Land at Bird in Eye Farm
South of Bird in Eye Hill
Uckfield

Planning Reference: WD/2021/2198/MAO

HIGHWAY NOTE

MT/5330/HN.2
November 2022

CLIENT	Croudace Homes Ltd.	DATE	09/02/22
PROJECT	Bird in Eye, Uckfield	DESIGN BY	-
TITLE	Swept Path Analysis Refuse Vehicle Right Turn Lane (Option 2)	DRAWN BY	ARM
DRAWING No.	5330 / 227	CHECKED BY	MT
		SCALE	1:500 @ A3
		REV No.	A

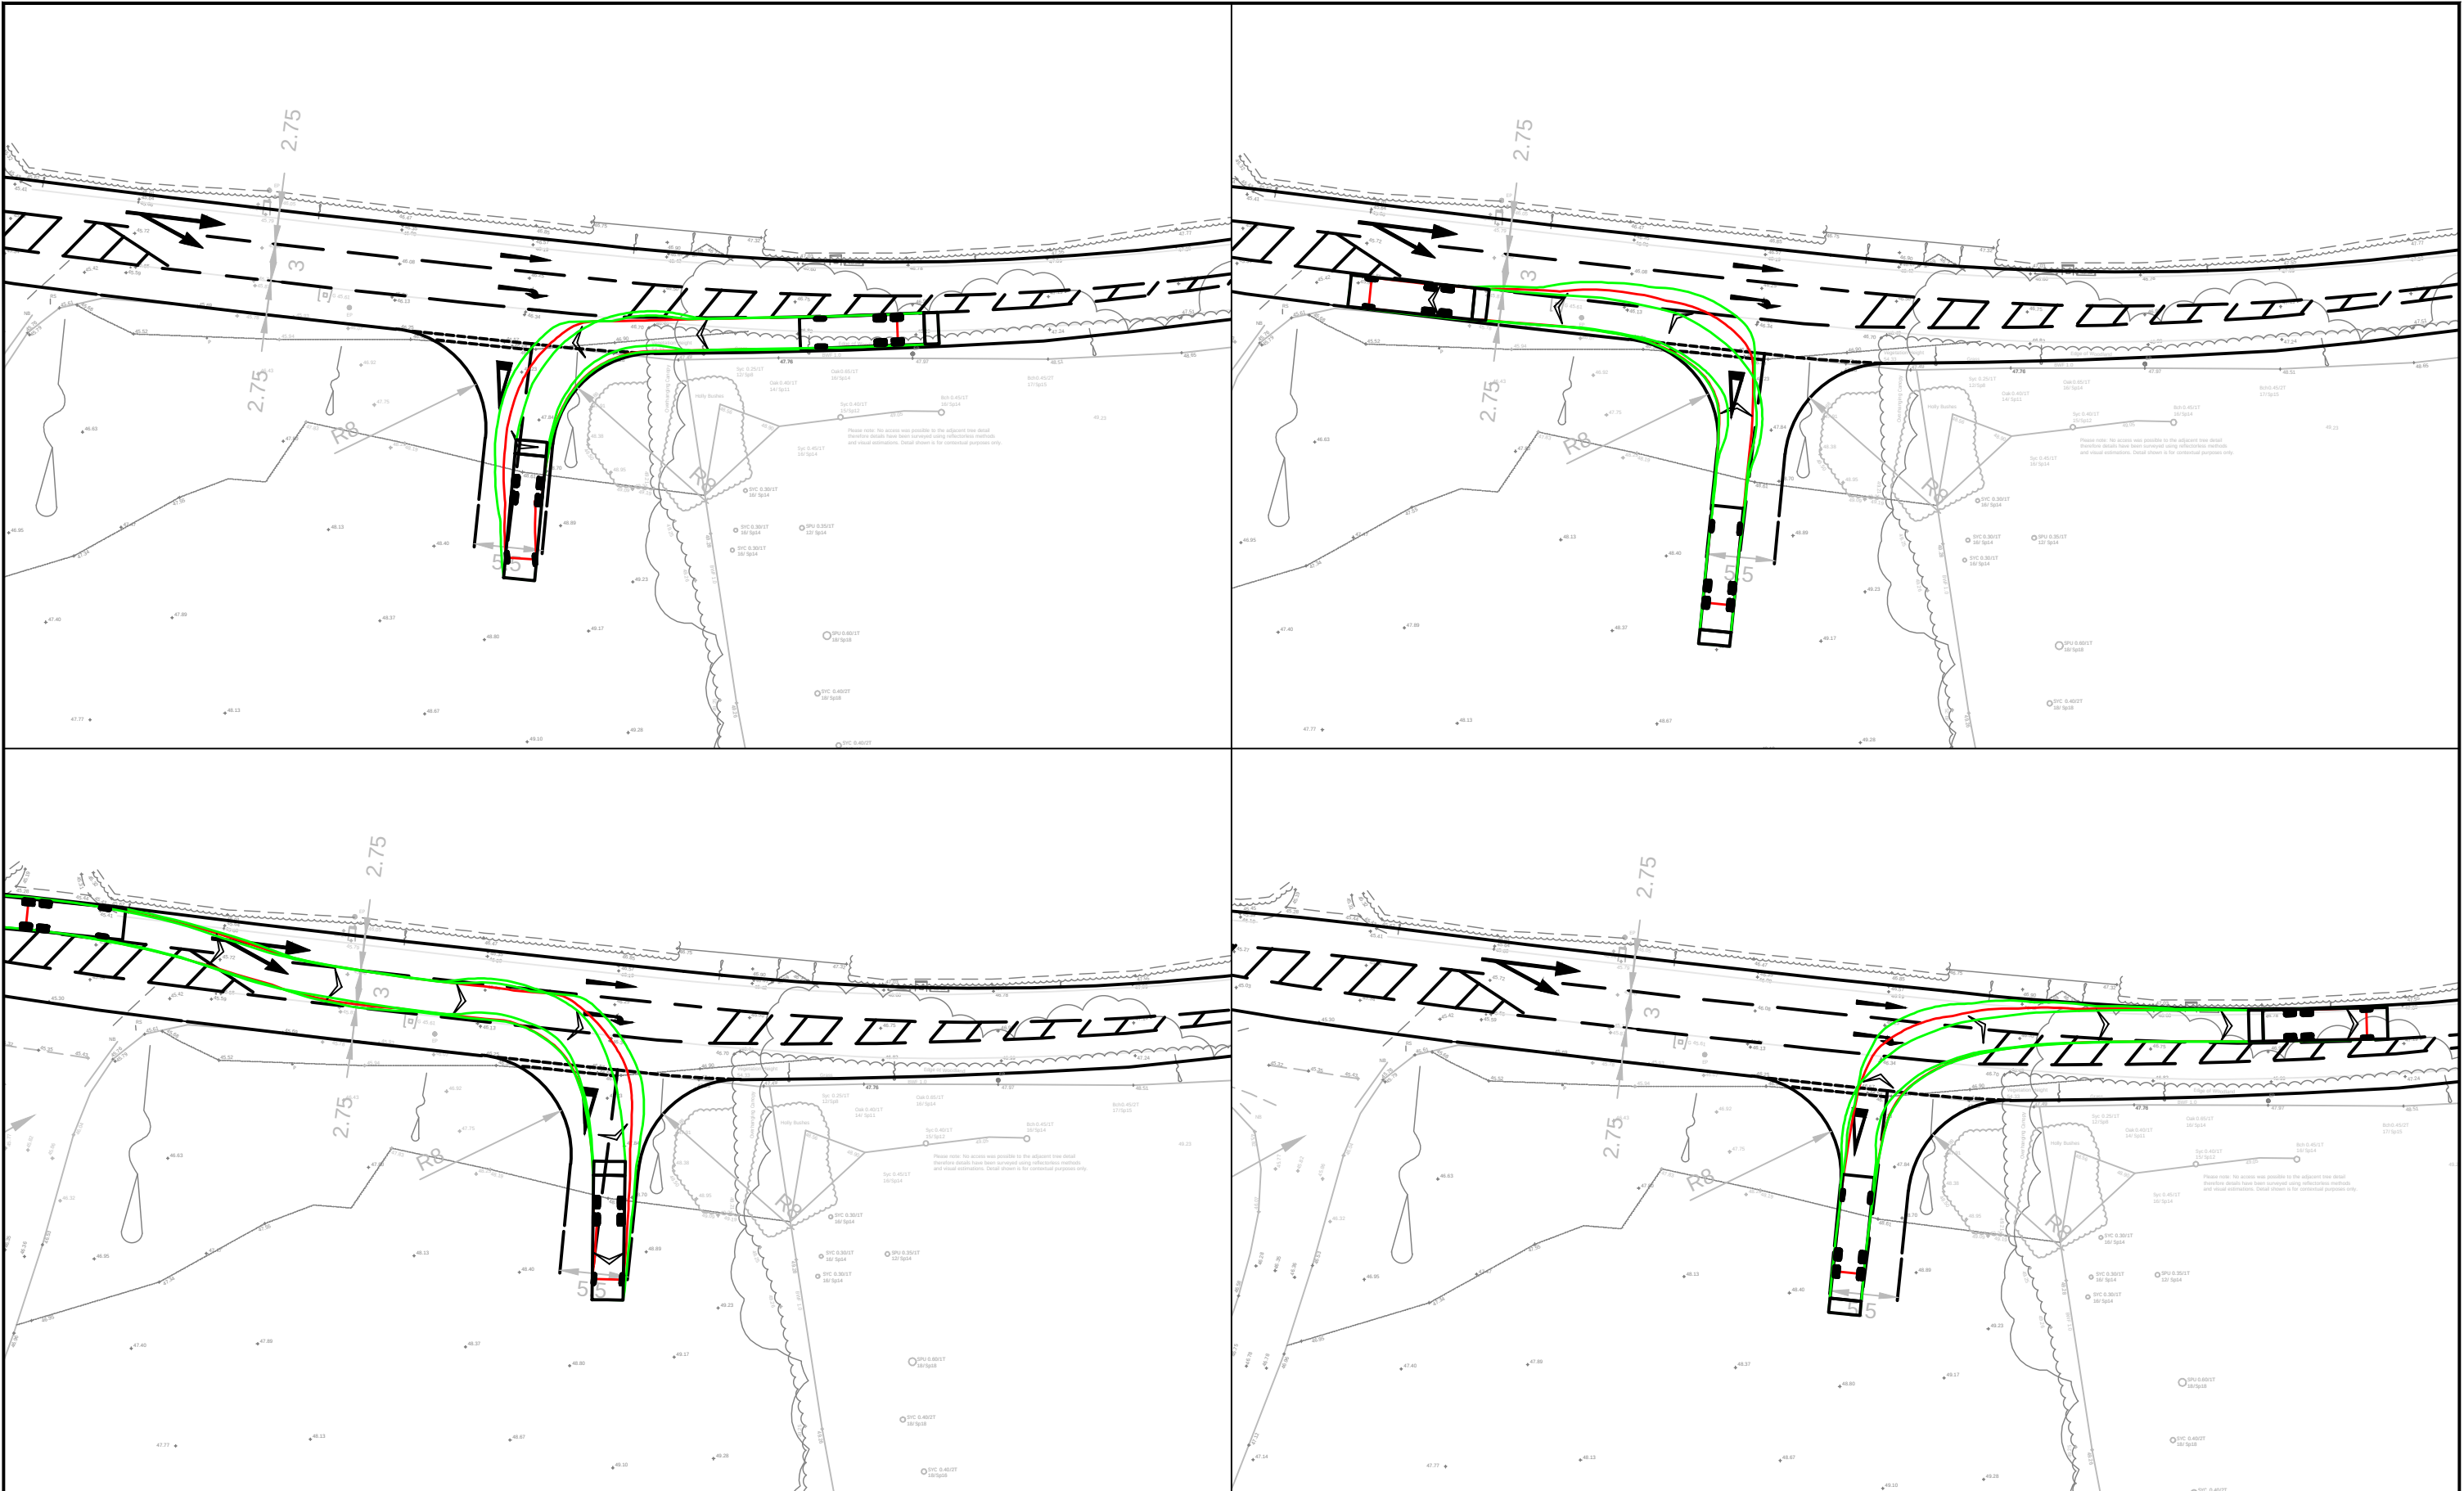
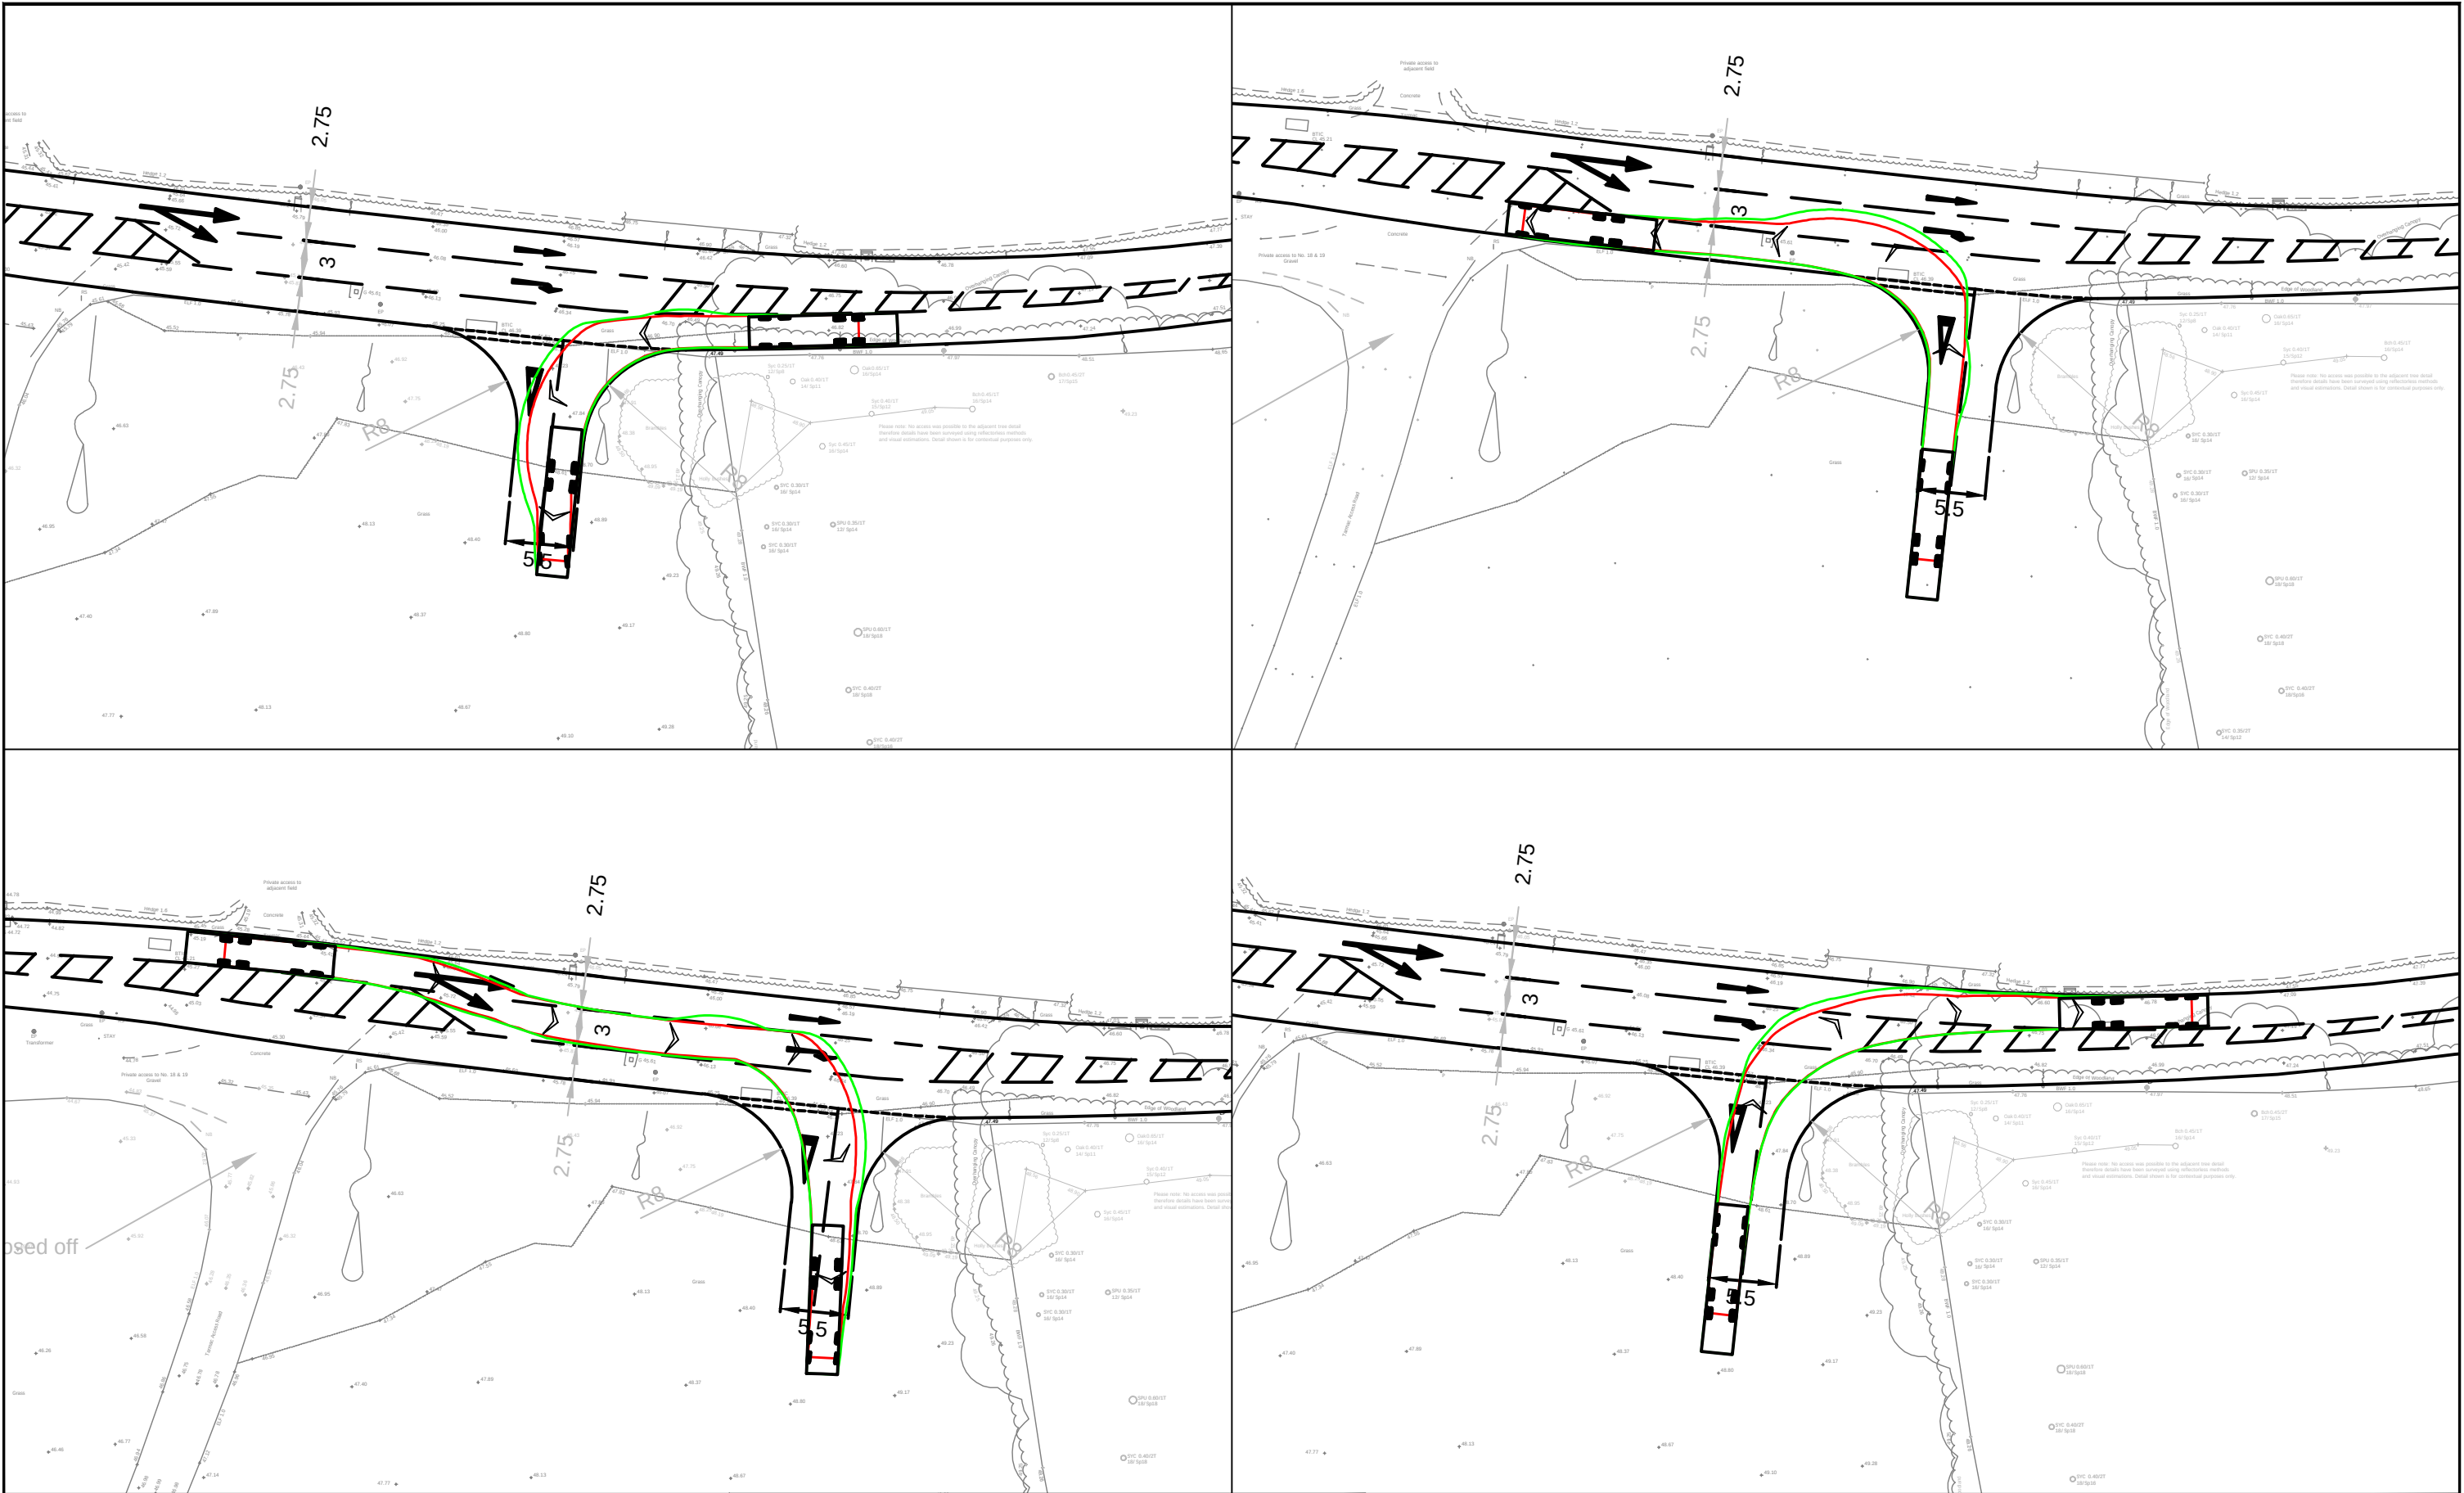
A.3	JUNCTIONS
A.3.1	PROBLEM
Location:	Proposed access arrangement
Summary:	Vehicles may encroach the opposing lane when manoeuvring
Acc Type:	Sideswipe type collisions
<p>The existing access to Bird in Eye Farm is approximately 5 metres wide with large corner radii that appear to have been extended to incorporate tapers which is likely to have been as a result of Heavy Goods and Agricultural Vehicles encroaching outside the original carriageway. The proposals include the relocation of the priority junction that is to allow access to a 5.5m wide carriageway and be formed with 8 metre radii. The Audit Brief does not include a plan illustrating a swept path analysis and therefore the Audit Team are unsure if the expected vehicles can be accommodated within the carriageway. It is understood that the existing commercial uses that are accommodated at Bird in Eye Farm, are to be retained and whilst no details have been provided to identify the expected vehicles, there are concerns that large vehicles will encroach the opposing lanes of traffic. Whilst the front end of a large vehicle encroaching the opposing lane of traffic is generally not a road safety concern when infrequent on lightly trafficked roads like the existing access as a driver would not proceed until it is safe to do so, the manoeuvre undertaken frequently when opposed is likely to lead to head-on and rear end type collisions as a result of heavy braking. Further, the trailer of a large vehicle swinging out into the path of opposing traffic will not be expected and could lead to sideswipe and loss of control type collisions.</p>

RECOMMENDATION:	
It is recommended that an entry and exit taper is provided to allow for the expected vehicles to manoeuvre with minimal impact on opposing traffic.	
Location Plan: <div style="display: flex; align-items: center;">   </div>	
DESIGN ORGANISATION RESPONSE provided by Bellamy Roberts on the 2 nd November 22 following formal issue of this Stage 1 Road Safety Audit on the 20 th Oct. '22	
Disagree - Swept path analysis of a large rigid vehicle and refuse vehicle accessing and exiting the site has been undertaken, demonstrating that the proposed access is suitable to serve the scheme. See drawings 5330/227 & 228.

CLIENT	Croudance Homees Ltd.	DATE	02/11/22
PROJECT	Bird in Eye, Uckfield	DESIGN BY	-
TITLE	Three Articulated Vehicles Passing	DRAWN BY	MB
		CHECKED BY	MT
DRAWING No.	5330 / 239	SCALE	1:250 @ A3
		REV No.

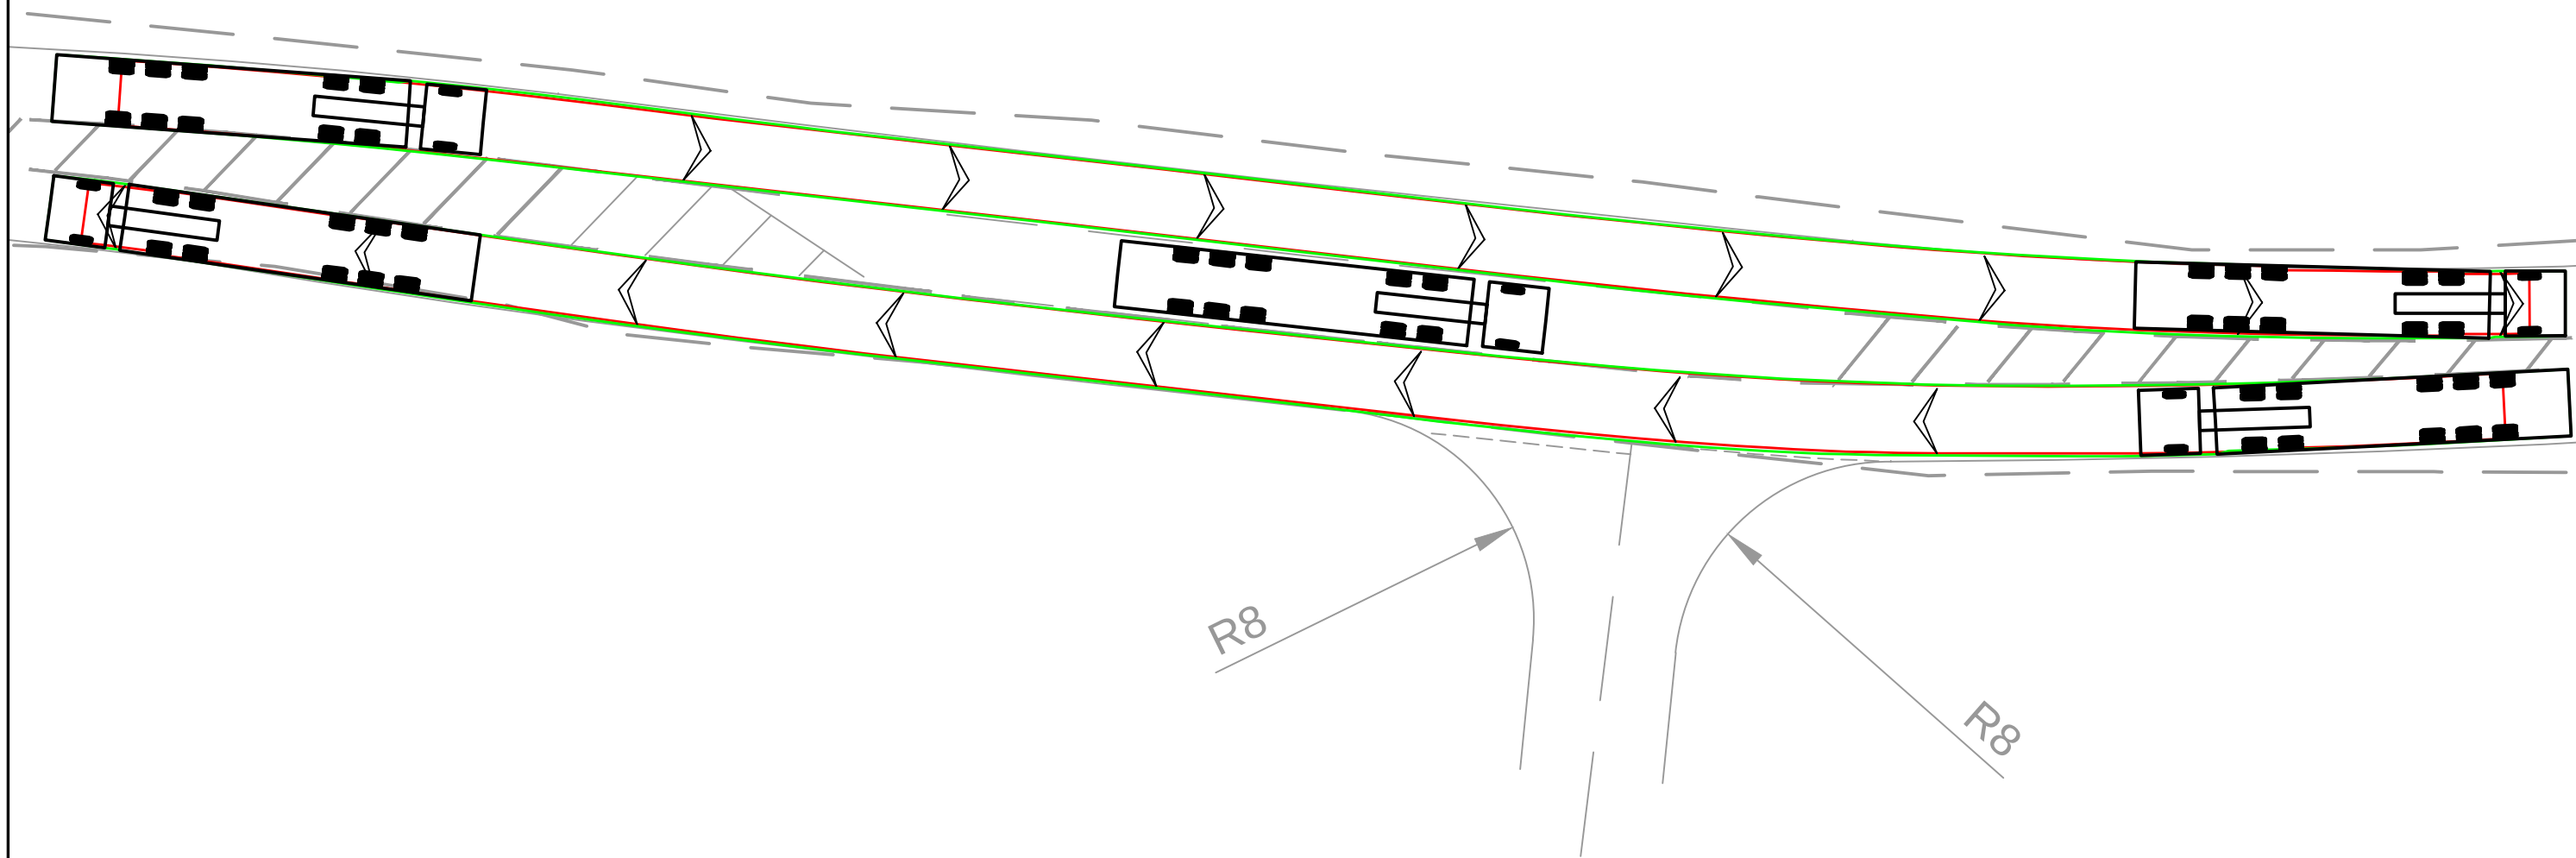
the southern side of the carriageway simple priority access off the southern side the carriageway. The proposed right turn lane is to be 3.0 metres wide with 2.75 metre through lanes. The Audit Team understand that a lane width reduction from 2.85 metres to 2.75 metres, can and does act as a traffic calming feature, however, have concerns that the proposed through lanes are too narrow for the expected vehicles. Narrow through lanes through could result in the need for vehicles to encroach the proposed right turn lane where vehicles could be waiting leading to sideswipe type collisions.

It is recommended that the proposed through lanes are adequate for the expected vehicles

Agreed - The existing Bird in Eye Hill carriageway is approximately 5.5m wide with lane widths of approximately 2.75m. These existing lane widths will remain constant through the proposed scheme. Nevertheless, swept path analysis has been undertaken which indicates that the 2.75 metre through lane width is adequate. See drawing 5330/239.
